REVISION TRANSMITTAL

This sheet transmits Revision 1 to SL750-32-33, which:

LANDING GEAR - INSPECTION OF THE NOSE LANDING GEAR STRUT ASSEMBLY INTERNAL ORIFICE ASSEMBLY FOR CORRECT INSTALLATION

SL750-32-33
 Page 1 of 11

Figure 1. Nose Landing Gear Shock Strut Orifice Assembly for Correct Installation (Sheet 1)

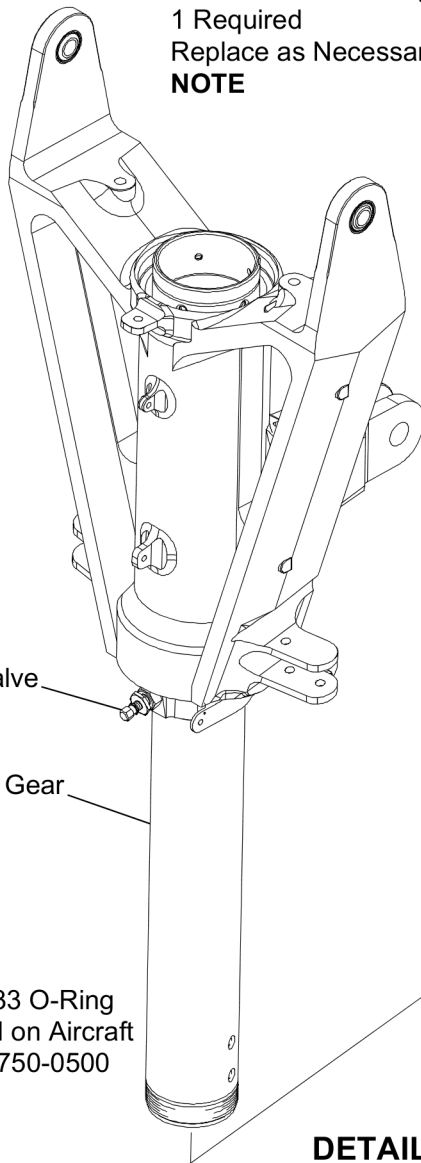
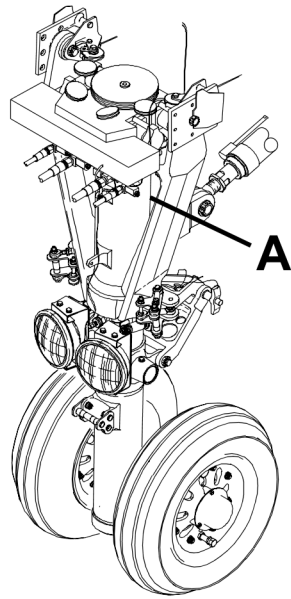
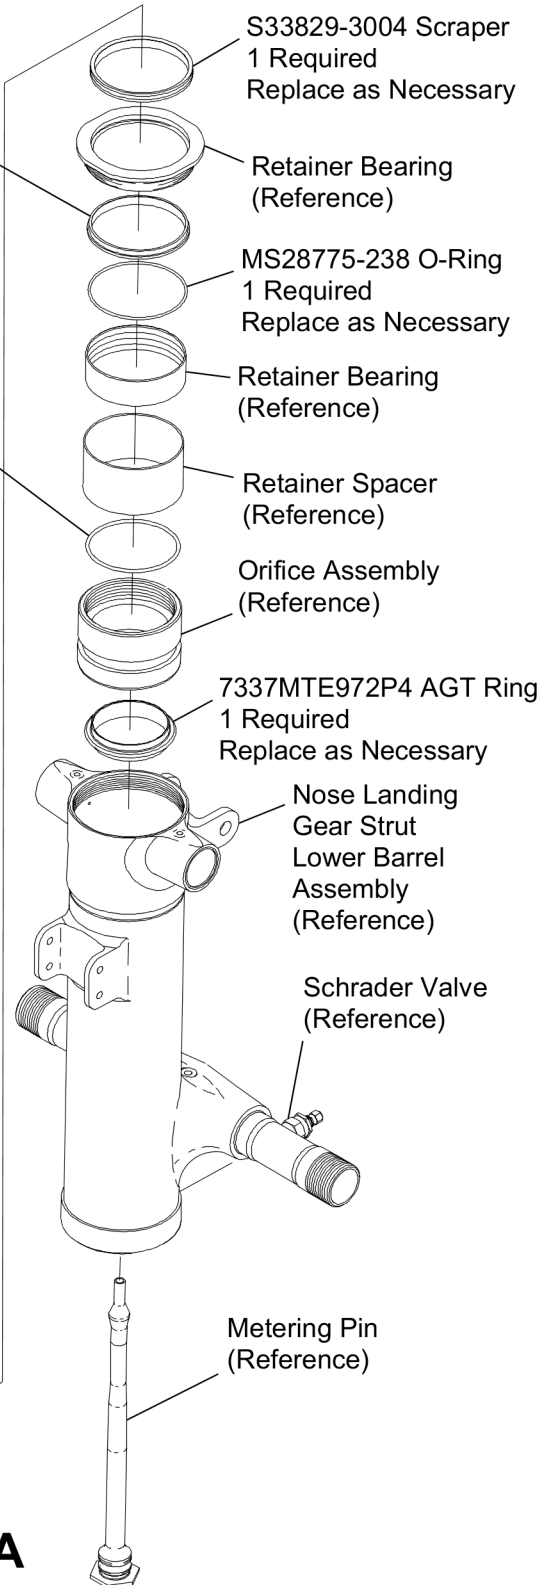
- H. Added SL750-32-29 reference to Step 10.
- I. Added SL750-32-29 references to Figure 1.
- J. Added Illustration Figure 1, Sheet 2
- K. Changed the Material Information section to add SL750-32-29 reference to part numbers S01279 and 7337FRE964P20.

- (8) Using a MPK wipe and brush, clean the threads of the orifice assembly and upper barrel assembly.
 - (9) (Refer to Figure 1, Sheet 1.) Aircraft -0001 thru -0309 that have not completed SL750-32-29, examine the nose landing gear strut S33829-3004 Scraper, S01279 Seal, MS28775-238 O-ring, MS28775-233 O-Ring and the M7337MTE972P4 AGT Ring for damage.

- (a) If the scraper, seal, O-rings or AGT Ring are damaged, replace as necessary.
 - (10) (Refer to Figure 1, Sheet 2.) Aircraft -0001 thru -0309 that have completed SL750-32-29 and -0310 thru -0532, examine the nose landing gear strut S33829-3004 Scraper, 7337FRE964P20 Seal Assembly, MS28775-238 O-Ring, MS28775-233 O-ring (-0001 thru -0500 only) and 7337MTE972P4 AGT Ring.
